CITY OF WEST DES MOINES
CITY COUNCIL MEETING COMMUNICATION

ITEM: Mills Crossing Kum & Go, 5901 Mills Civic Parkway – Consideration of an Overlay District Site Plan to construct a 4,992 sq. ft. convenience store with gas pumps – Kum & Go, LLC –
OSP-002563-2014

Item: Mills Crossing Kum & Go, 5901 Mills Civic Parkway – Denial of site plan to construct a 4,992 sq. ft. convenience store with gas pumps – Kum & Go, LLC – OSP-002563-2014

KUM AND GO #532 AT MILLS CROSSING
WEST DES MOINES, IOWA
SITE PLAN - PARCEL 'A'(DIMENSION & LANDSCAPE)

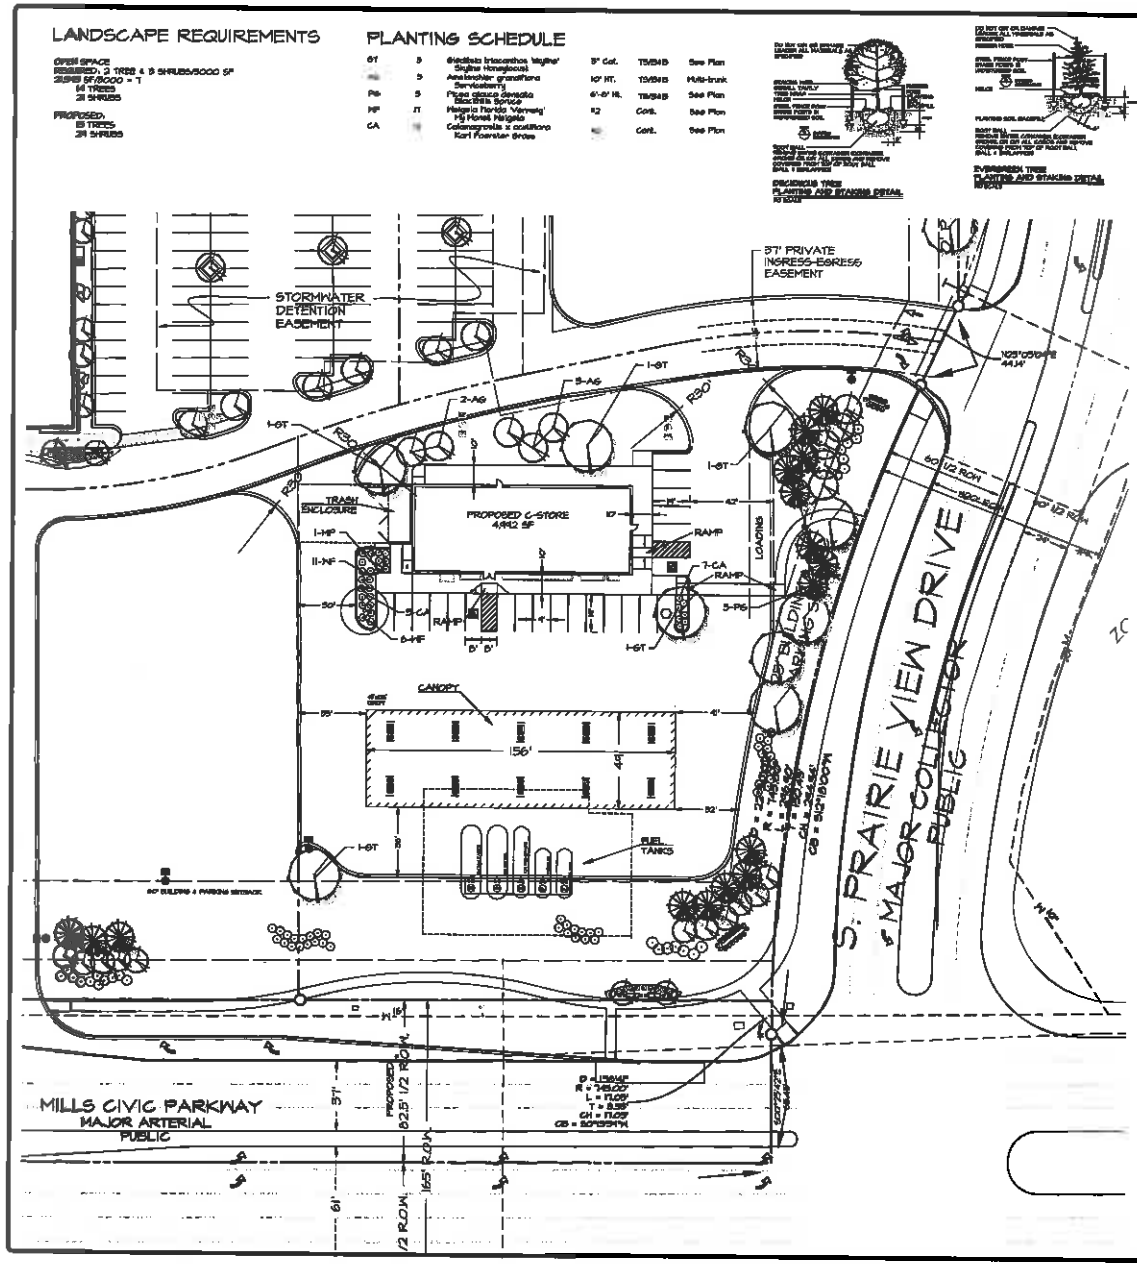
1. Applicant's Proposal – The applicant is proposing the canopy be located at the south end of the property, parallel with Mills Civic Parkway and adjacent to S Prairie View Dr; the store is proposed to be located to the north. There is some earthen berming and landscaping along both Mills Civic Parkway and S. Prairie View Dr.; per the applicant, they are intending to provide view windows into the site. Staff believes that failure to locate the store at the corner, in conjunction with placing the largest mass of the vehicle use element in a highly visible location is inconsistent with the intent of the Town Center Overlay District. The Plan and Zoning Commission recommended approval of this store and canopy orientation within the site with conditions that the applicant maintain the height of the berm and shift landscape vegetation for better screening. Staff has concerns that the applicant's idea of level of screening and allowable visibility and the intent of the Commission may not be one in the same. While staff has indicated that Kum & Go would be held to the same standard as Casey's was in regards to the amount of vegetation required, staff believes that placement of the canopy up front and immediately adjacent to Mills changes the parameters for screening and results in the need for additional vegetation above and beyond the minimum in order to achieve more complete visual screening.

Recommendation - Staff stands behind the recommendation of denial of the applicant's proposed layout and recommends that approval be either the "Ideal Orientation" which places the store parallel with and adjacent to Mills Civic and canopy to the north; or the "Second Option" which places the store parallel with and adjacent to S. Prairie View Drive with the canopy situated west of the store and perpendicular to Mills Civic Parkway. Staff does not recommend the approval of the third option as we believe that this orientation offers the longest duration of views of the largest mass of the canopy and thus is least consistent with the intent of the Overlay District. As indicated above, if choosing between the canopy being located adjacent and parallel with Mills Civic Pkwy or adjacent and parallel with S Prairie View Dr., staff believes the orientation adjacent to Mills Civic Parkway is the better of the two choices.

Specific Plan: The Specific Plan Ordinance for Mills Crossing provides for appropriate site design measures to be implemented to minimize the presence and visibility of canopies. Staff believes the proposed site design, with the primary vehicle use element of the canopy being located at the corner and parallel with Mills Civic Parkway, puts the largest aspect of the vehicle canopy mass visible from the roadway and the first thing encountered visually is counter to the intent of the Specific Plan Ordinance and the guidelines of the Town Center Overlay District.

The Specific Plan Ordinance also provides that the vehicle use area will be screened through landscaping to minimize the visual presence and impact of the structure on surrounding properties, businesses, and public streets. Said screening shall be achieved through the use of location and/or earth berming and landscaping consisting of evergreen material for year-round screening. Staff feels that the vehicle use areas being located on the corner of the intersection are not effectively screened by the proposed landscaping in the manner outlined in the Specific Plan Ordinance.

- Section 3.1 Building Placement for Commercial, Office, and Mixed Use Guidelines: *"Locate buildings close to the street, with off street parking behind or beside the building"*. The proposed site plan does not locate the building close to the intersection of Mills Civic Parkway and South Prairie View Drive, the two major streets at this corner and the canopy and parking is located between the building and both Mills Civic Parkway and South Prairie View Drive.

- Section 3.3 Vehicle Use Area Design: *"Parking areas should...be located so as not to be the dominate feature along any street or intersection"*. Due to their location, the vehicle use area and parking are considered the dominate feature as these areas are proposed to be located along the street and at the intersection and the first element encountered. Given the size and mass of the canopy, the visual presence of the element is great.

1. That the landscape plan indicating the proposed berming and placement of landscaping to buffer and block the visibility of the canopy element;

4. That the pedestrian area along Mills Civic Parkway, adjacent to the DART bus stop, be constructed with this site plan and prior to issuance of a final occupancy permit;

EXHIBIT II

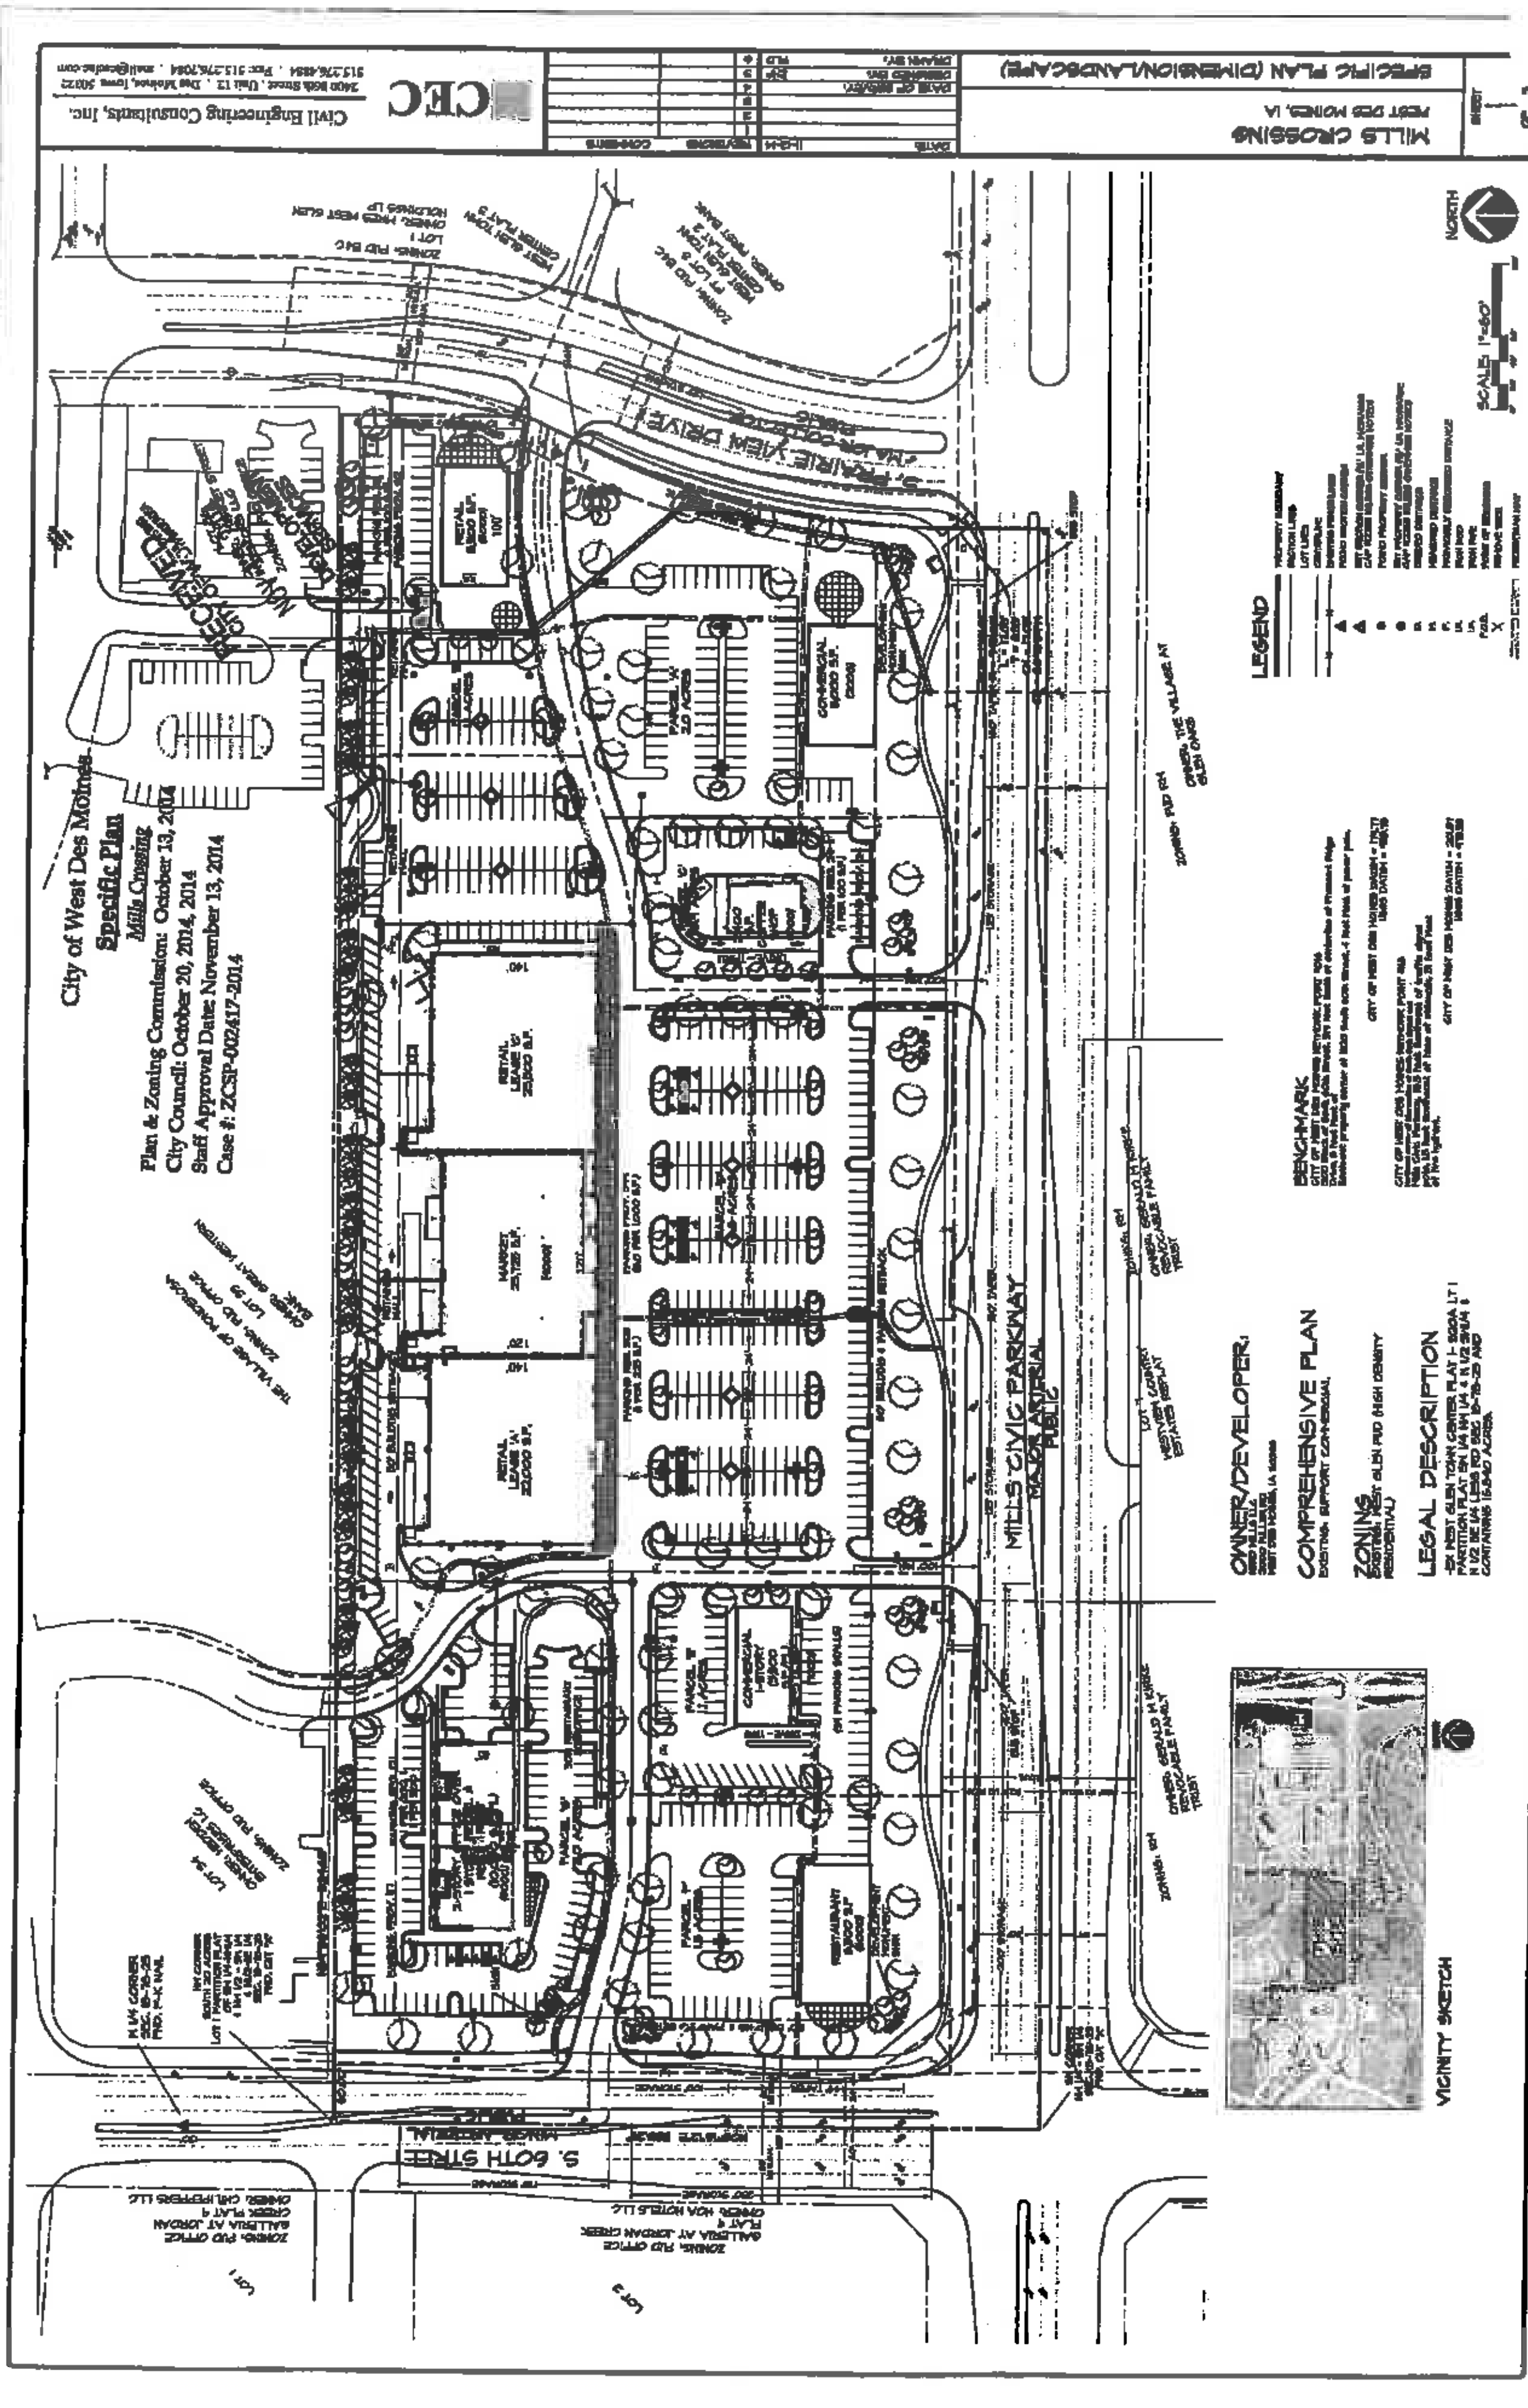
Approved Specific Plan: For the Council's convenience, a copy of the approved Specific Plan Ordinance Sketch is included under Exhibit II – Specific Plan. The Specific Plan was presented for Council approval showing one commercial building at the corner consistent with the Overlay District with full knowledge that Kum & Go was continuing to propose to locate the canopy along Mills Civic Parkway and at the corner. This was done in order to fulfill the requirement for an adopted Specific Plan prior to development so that the developer, Hurd Mills LLC, could proceed with development of other areas of the Mills Crossing development.
